Product Change Notification

Change Notification #: 114555 - 01
Change Title: Select Intel® Processors,
PCN 114555-01, Product Marking,
Implementation of 2 Alpha Character
Country of Origin Code on Mark
Reason for Revision: Country of Origin
Translation Table Update
Date of Publication: June 1, 2016

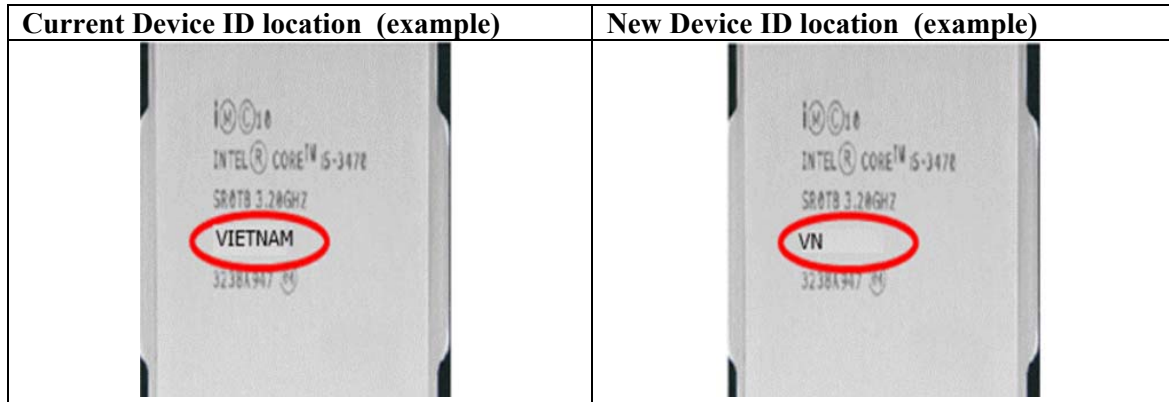
For standardization purposes, Intel will be implementing a new two alpha character Country of Origin (COO) mark on all lidded Intel products. This change will replace the current full character COO (e.g. USA) mark content with the new two alpha character COO (e.g. US) on the products listed in the "Products Affected/Intel Ordering Codes" table below.

The new COO marking change will be visible to customers, however this change will not impact product performance, quality, reliability, interchangeability, functionality or manufacturability. This is only a visual change to these products.

See the images provided for current and new marking comparison and Country of Origin Translation Table for reference.
